# ADDENDUM NO. 1

Carmel Clay Schools 2025 Landscape Improvements  
5201 E. Main Street  
Carmel, IN 46033

TME/CWE/PTE/FDE/WCE/T2 - Landscaping

Project No. 224135.00

Trio Bench

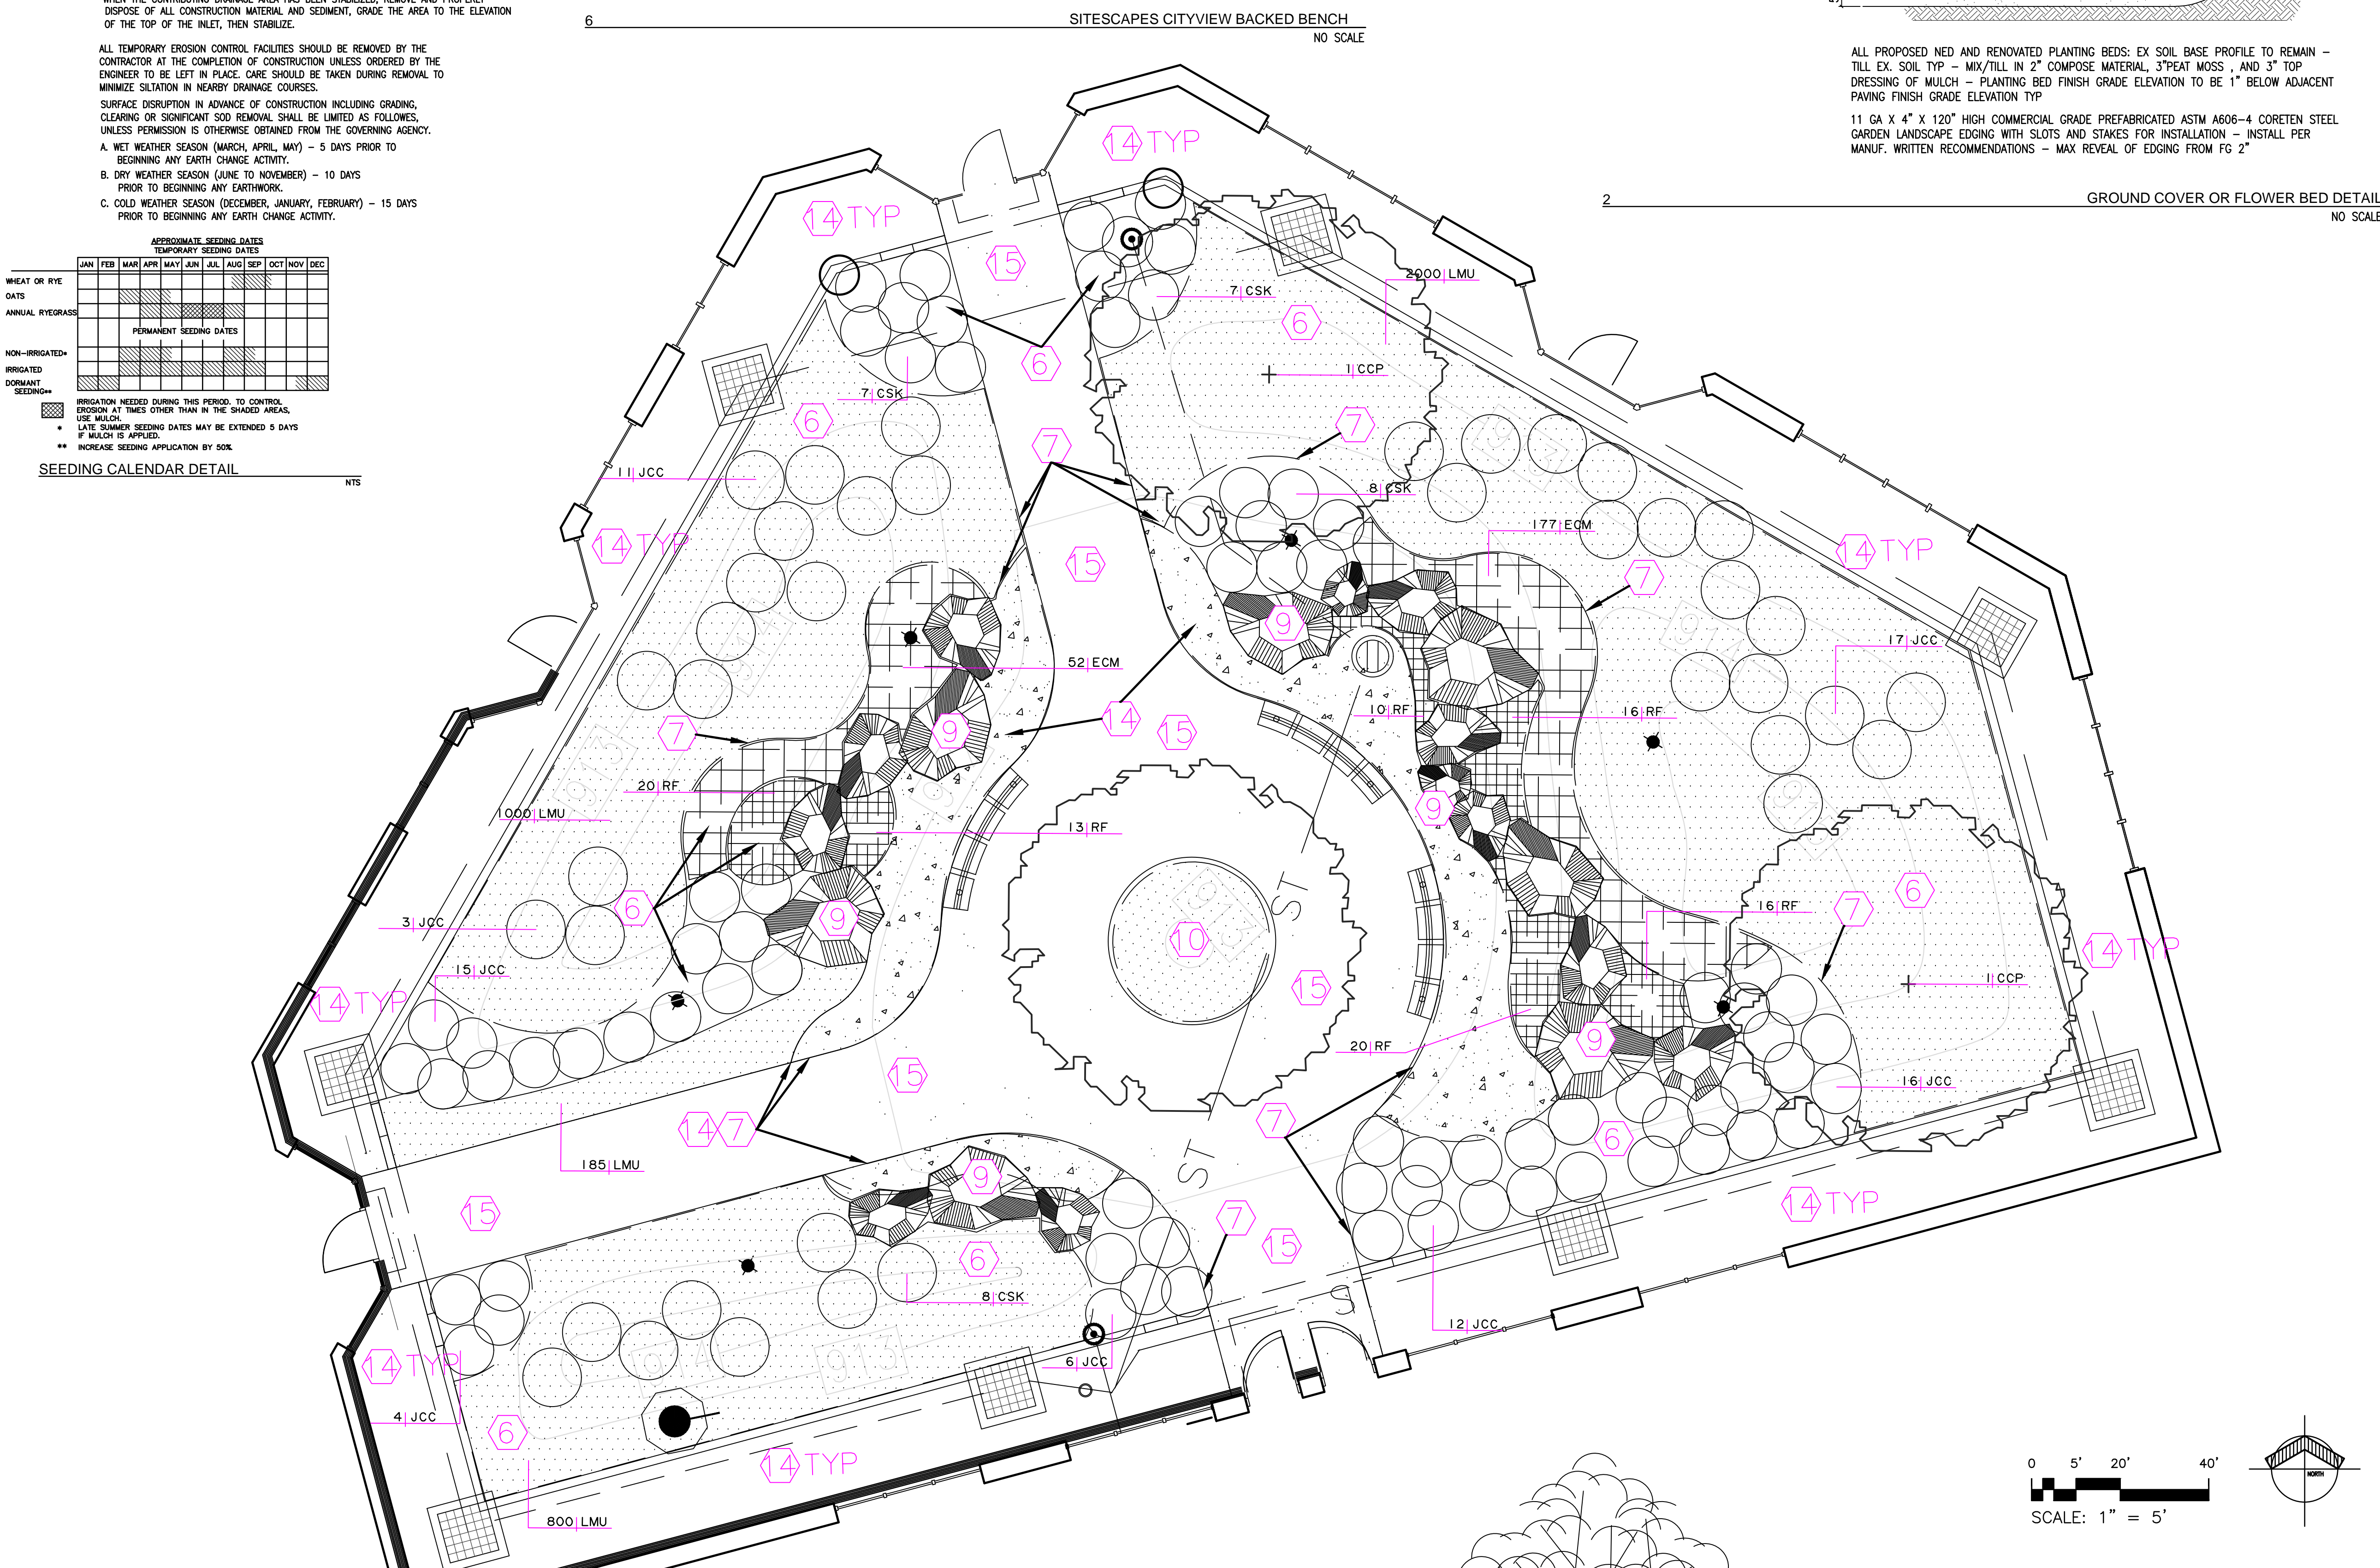
C. Replace 2.2, A., as follows:

“A. Bench: “Trio Bench” by Forms and Surfaces, forms-surfaces.com, 800-451-0410, 5055 6<sup>th</sup> St., Carpinteria, California, 93013. Prior to bidding a manufacturer seeking approval as an equal shall provide a complete set of all related furniture information to show compliance with matching features of the bench specified.

1. Quantities and sizes as indicated on Drawings.
2. Surface mount benches per manufacturer’s written instructions.
3. Field verify final location with Landscape Architect prior to installation.
4. Color shall be selected from Manufacturer’s standard colors.
